SHINE Medical Technologies, Inc. Application for Construction Permit
Response to Request for Additional Information

**SHINE MEDICAL TECHNOLOGIES, INC. APPLICATION FOR CONSTRUCTION PERMIT
RESPONSE TO REQUEST FOR ADDITIONAL INFORMATION**

**REVISION 1 OF THE SHINE RESPONSE TO RAI 11.2-4
(PUBLIC VERSION)**

RAI 11.2-4

Figure 11.2-4-1: RLWE Liquid Waste Evaporator and Storage System Process Flow Diagram

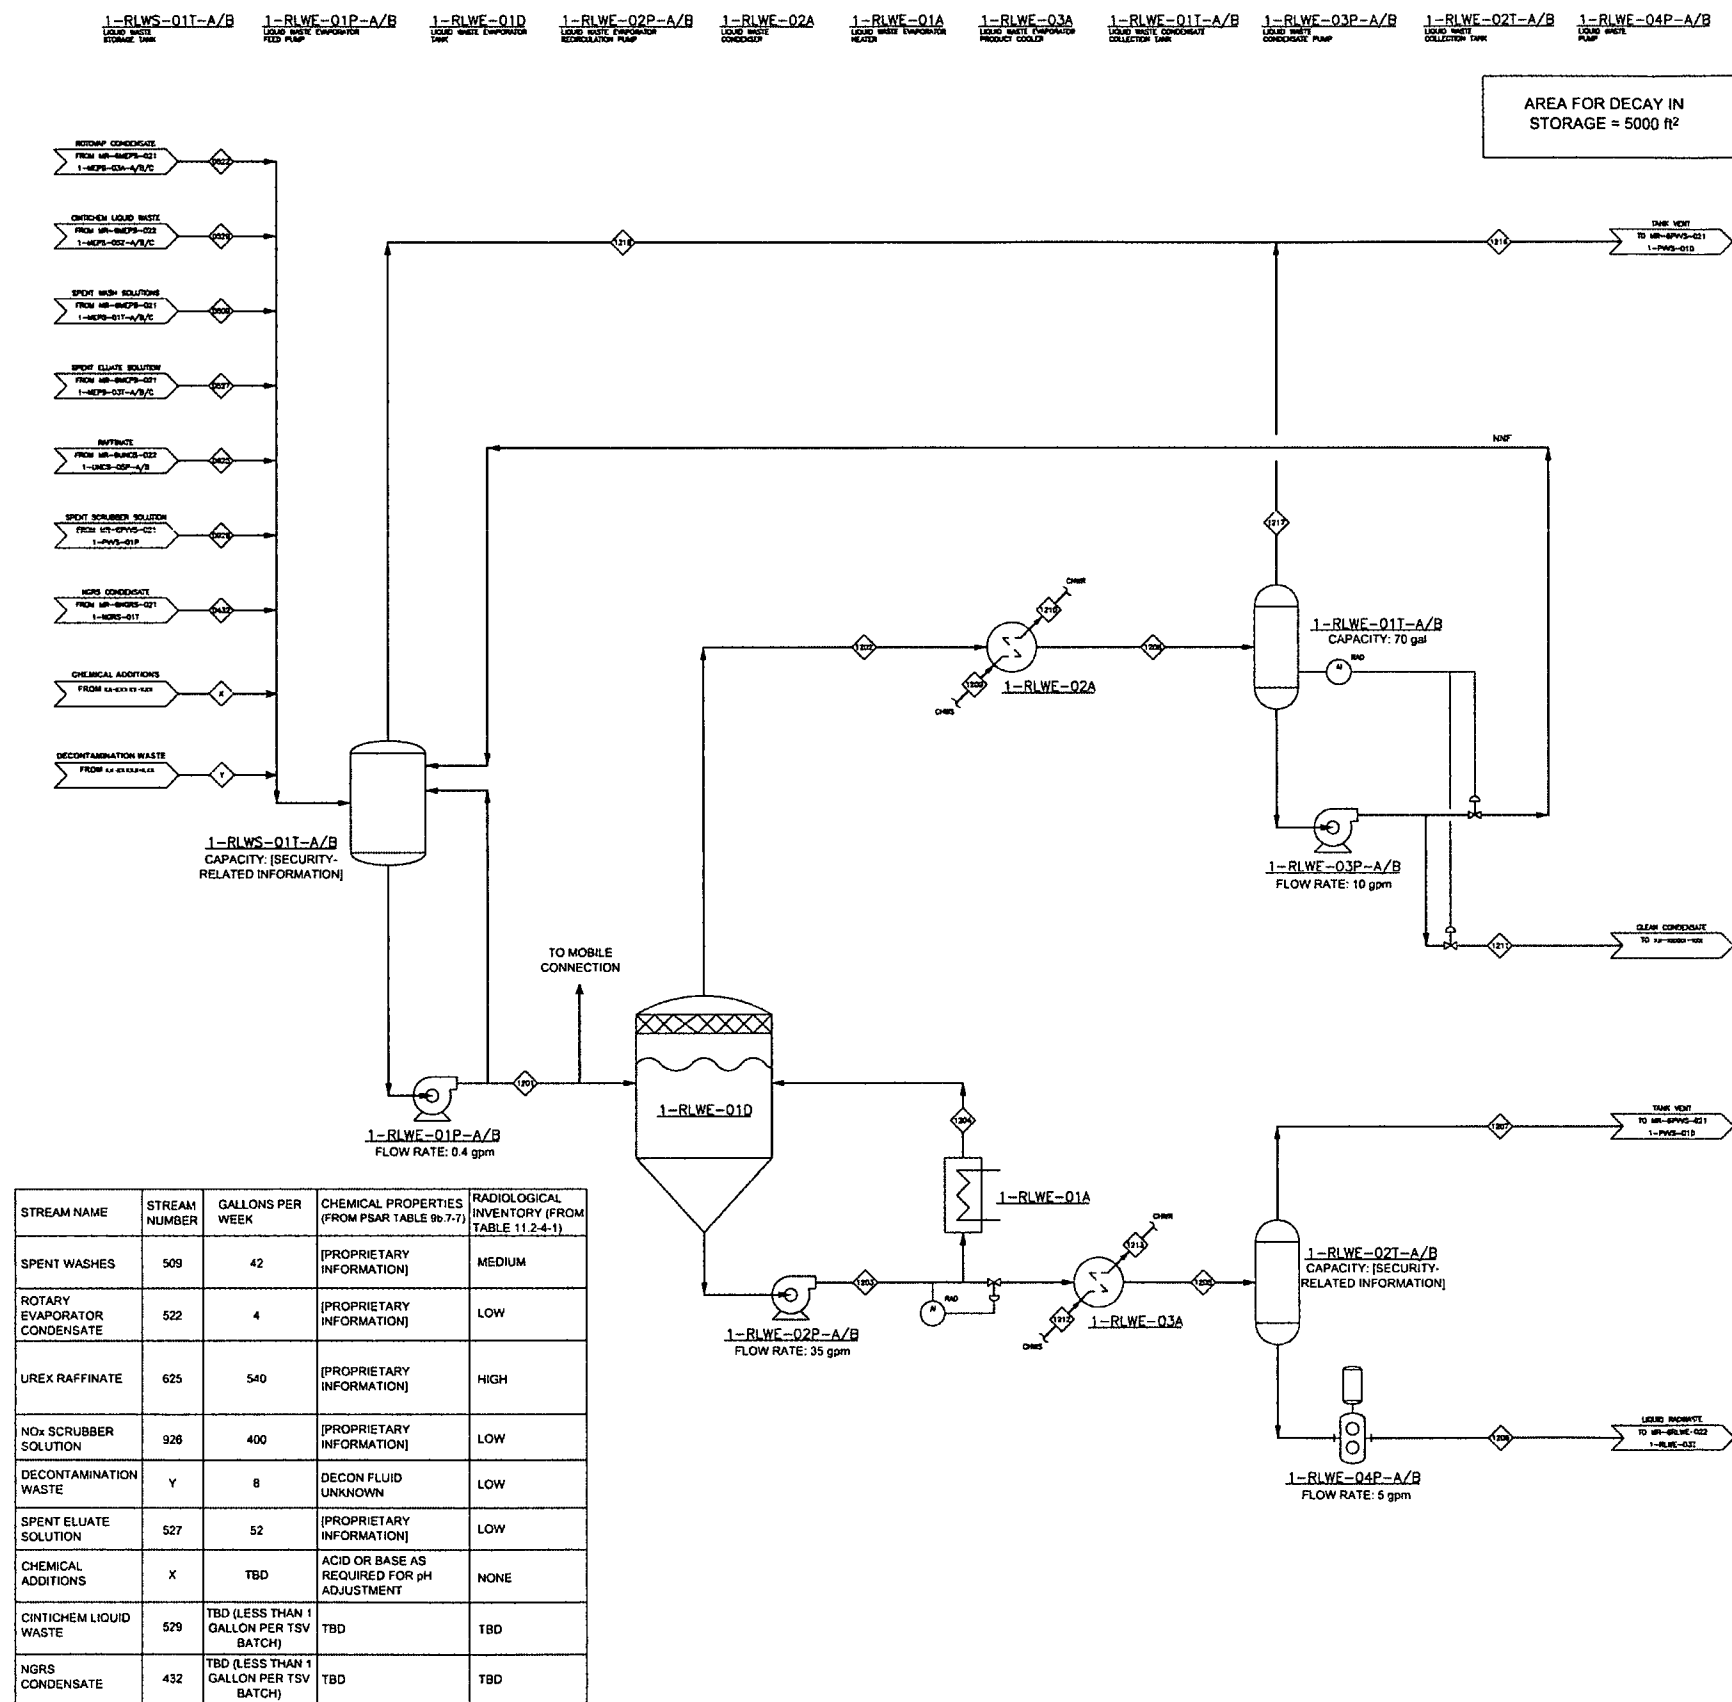
Provide a comprehensive liquid waste process flow diagram showing expected liquid waste generation rates (with chemical and radiological properties) for all liquid waste streams, washes, rinses, and chemical additions that flow to the consolidated radioactive liquid waste tanks. The process flow diagram should also quantify tank capacities and processing flow rates that demonstrate the capability to process wastes from normal operations and anticipated upset conditions with margin, or identify locations for interfacing with temporary mobile systems, as needed. The process flow diagram should include an estimate of the area needed for decay in storage of packaged waste and the criteria used to determine shielding requirements.

A liquid process flow diagram is provided as Figure 9b.7-5 of the PSAR. Figure 11.2-4-1, below, provides a modified version of Figure 9b.7-5 showing expected liquid waste generation rates and chemical and radiological properties for the liquid waste streams, washes, rinses, and chemical additions that flow to the liquid waste storage tanks (1-RLWS-01TA/B). Figure 11.2-4-1 also shows tank capacities, processing flow rates, a location for interfacing with temporary mobile systems if needed, and an estimate of the area needed for decay in storage. SHINE will update Figure 9b.7-5 of the PSAR in the FSAR to incorporate the process details described above. An IMR has been initiated to track the update to Figure 9b.7-5 in the FSAR.
